Bid No. 13-CP-06

Rosemont Water Line Replacement

Addendum No. 2

FREDERICK COUNTY CONTRACT NO. 339A-SW
ROSEMONT WATERLINE REPLACEMENT

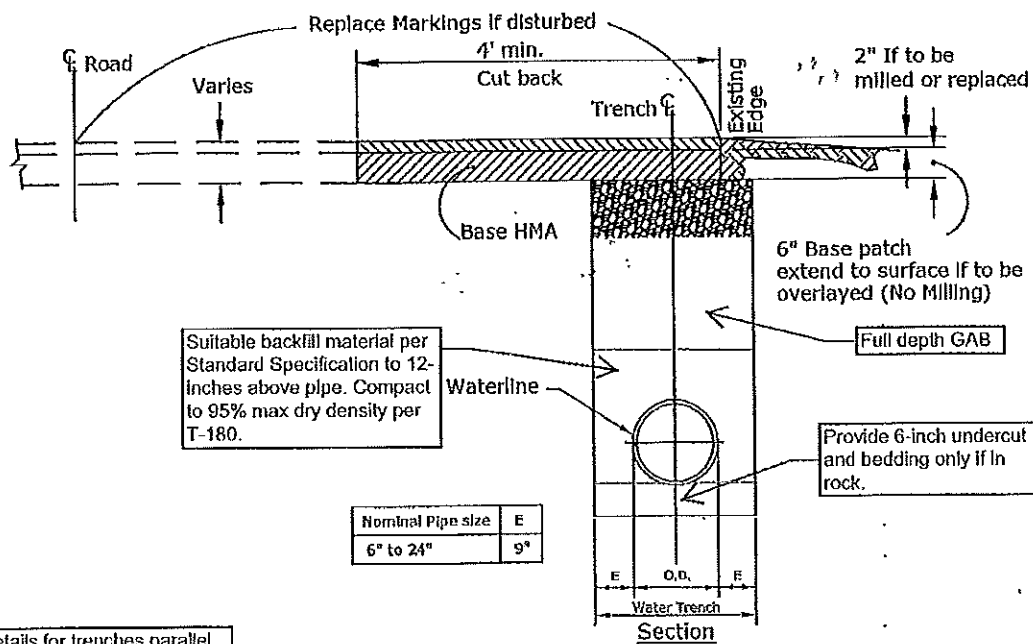
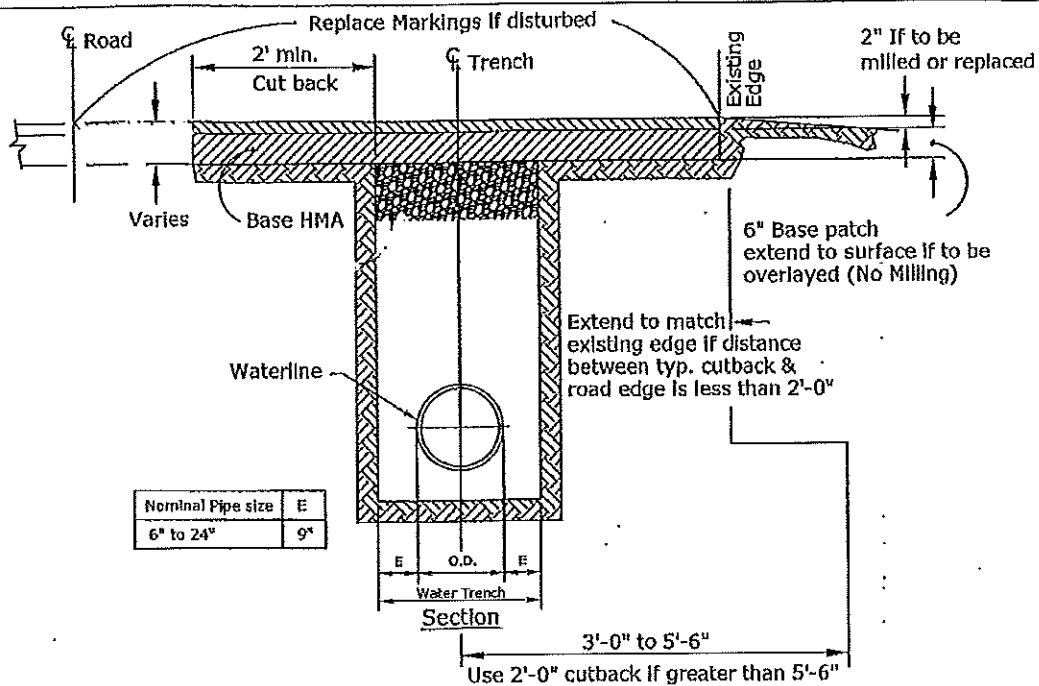
MD-SHA, detail 578.01 is hereby modified for this project. On the "Flexible Pavement" portion of the detail, the dimension for Hot Mix Asphalt Base is **CHANGED from 10" to 6"**.

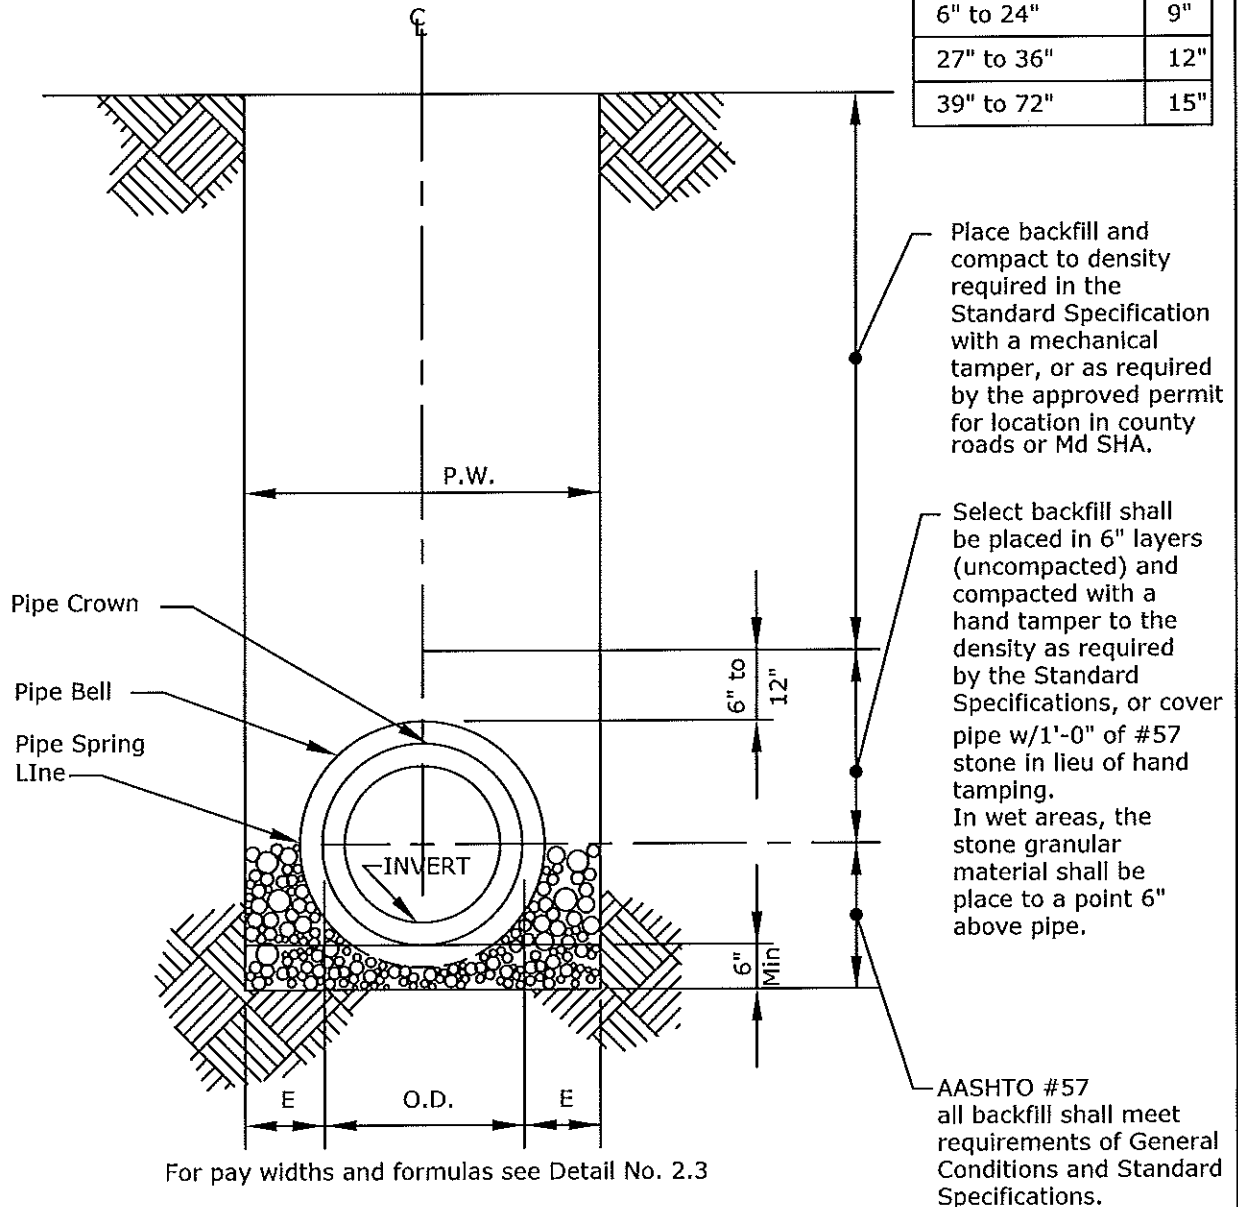
Question No. 10: Frederick County Standard Detail No. 2 indicates that no special bedding materials are required for ductile iron piping with the exception of areas where rock is encountered. Please confirm that pipe bedding for this project will be in accordance with Standard Detail No. 2 dated 2-20-80.

Answer 10: Please refer to Detail No. 2.1 attached herewith but stone bedding is not required for DIP. Note that backfill within the SHA R/W shall be full depth GAB from 12-inches above the pipe to the bottom of asphalt patch.

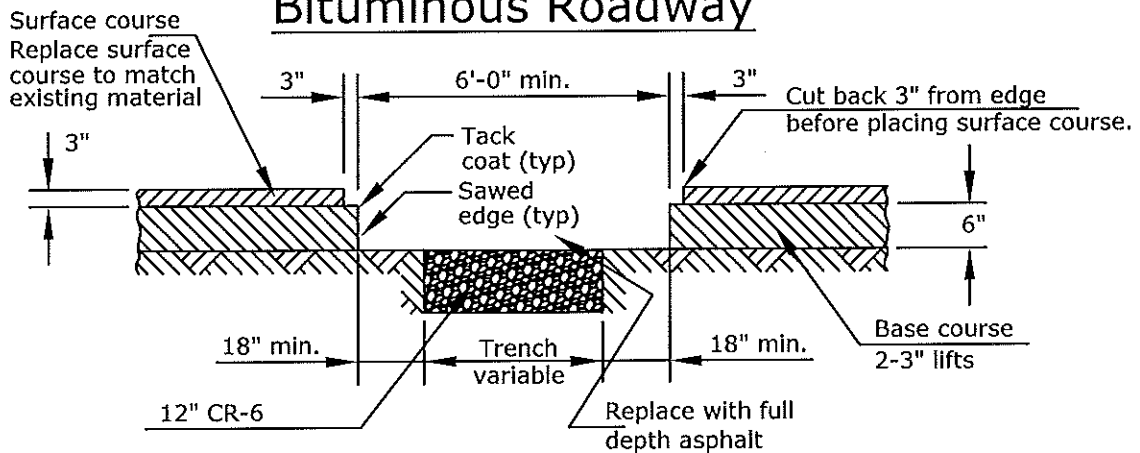
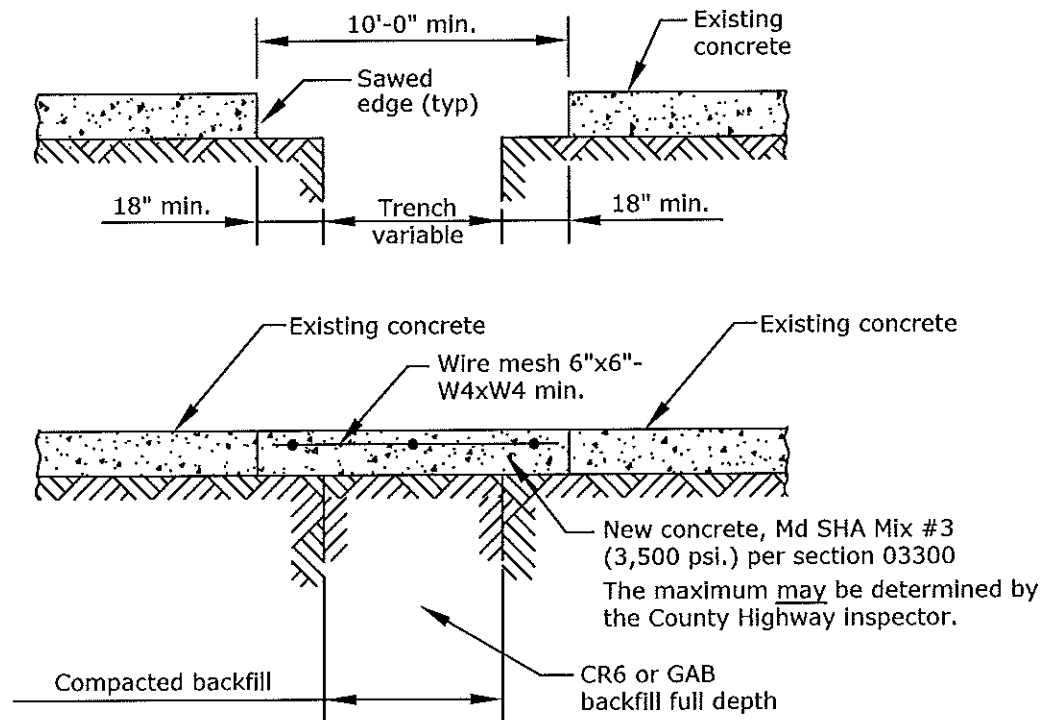
Question No. 23: The County Road Repair Detail No. 3.1 provided on plan sheet 12 illustrates two possible repair scenarios, one being 8” of reinforced concrete with 2” of bituminous asphalt surface and the other being full depth concrete with reinforcement. Please confirm where Detail No. 3.1 will be applicable on this project and what bid item will be used for measurement and payment as all current patching bid items are “Full Depth Hot Mix Asphalt”.

Answer 23: The Standard Detail 3.1 shown on sheet 12 is incorrect and hereby **DELETED**. Bidders should reference Frederick County Standard Detail No. 3.1 attached to this addendum. Detail 3.1 is used for all utility trench repair on County roads. Said detail is only included for unforeseen purposes.
